CONSULTEE RESPONSE (Council's Arboriculturist)

Reference: EP/62/22/T

Location: 1 Kerry Gardens, East Preston, BN16 1HQ

Proposal: 1no. oak tree (T1) reduce crown from 11m to 8m in spread and raise crown to be approx. 4m above ground level. 1no. yew tree (T2) raise crown to be approx. 1.8m above ground level. 1no. cedar tree (T3) reduce southern side by 2m leaving tree approx. 8m wide, remove deadwood

Figure 2 Positions of final cuts

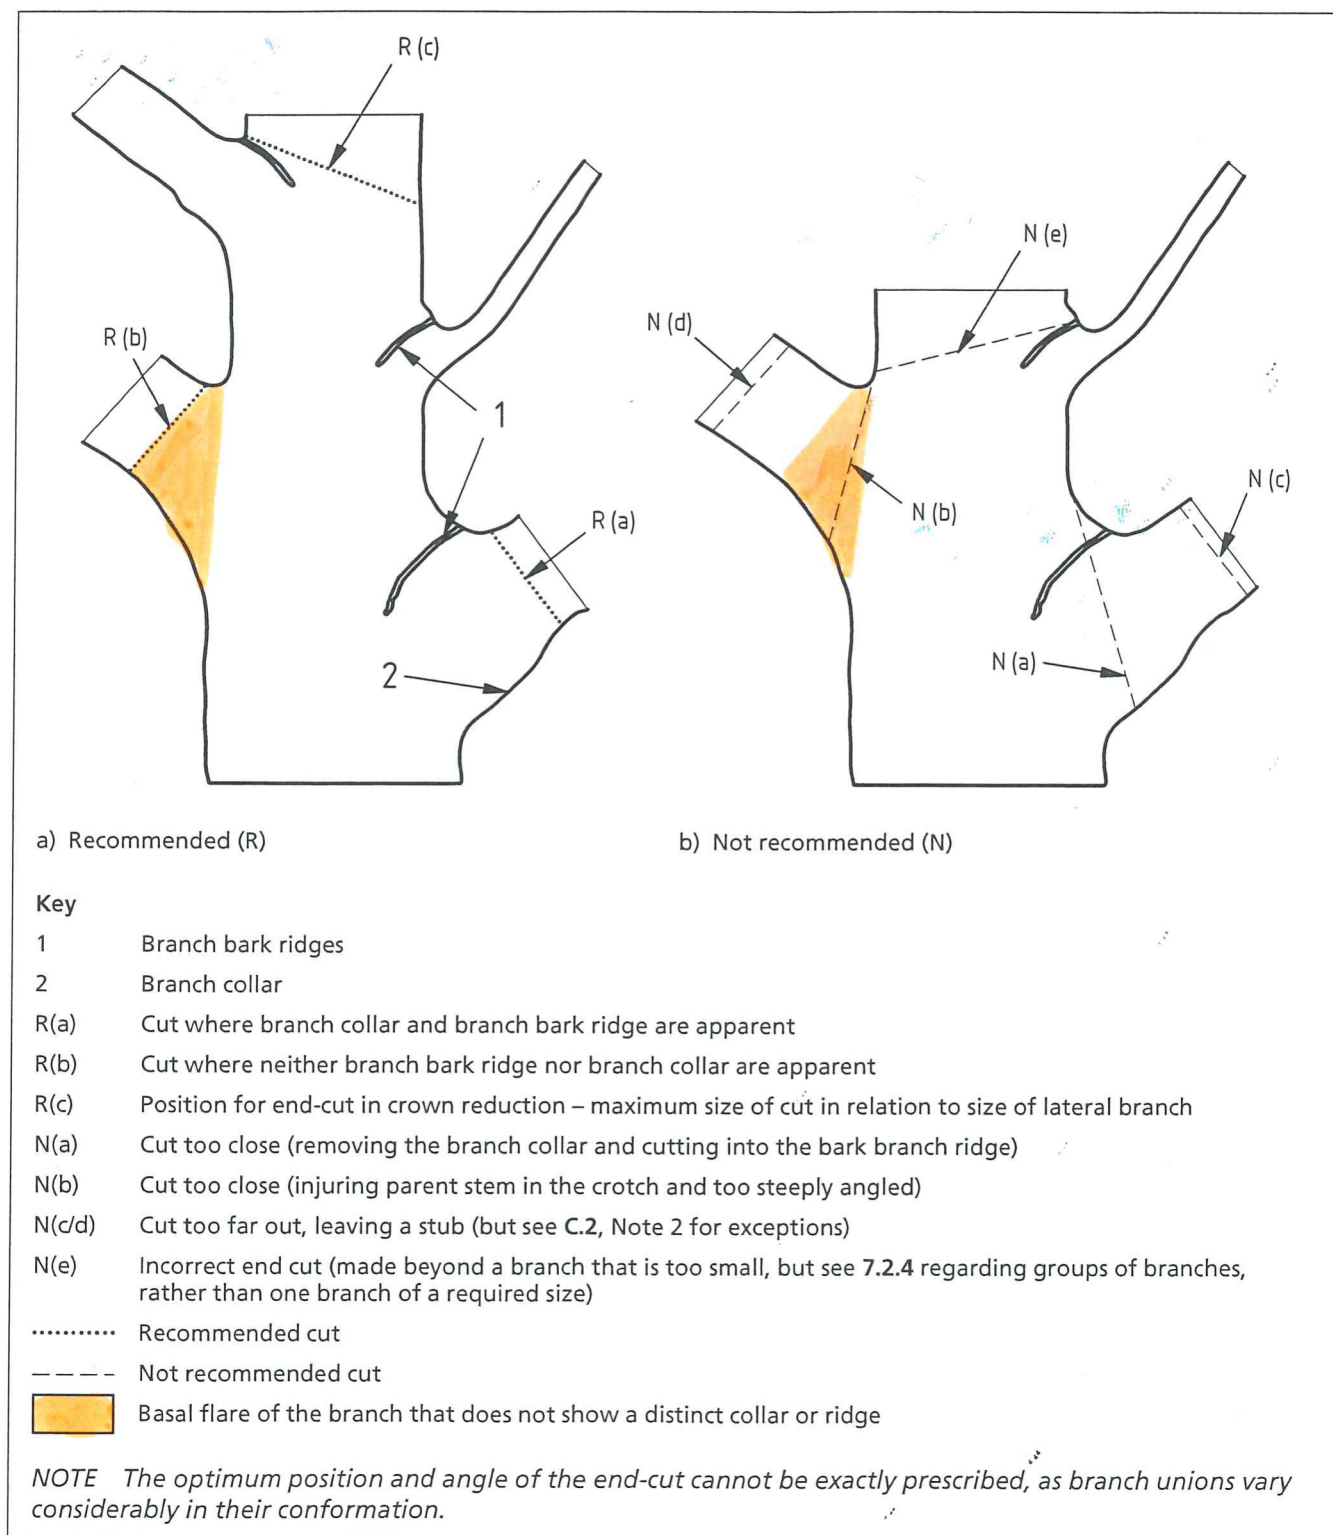
Part a) Where whole branches are to be removed and final cuts made close to the trunk or branch union they are to be made as shown in Figure 2 of BS3998:2010
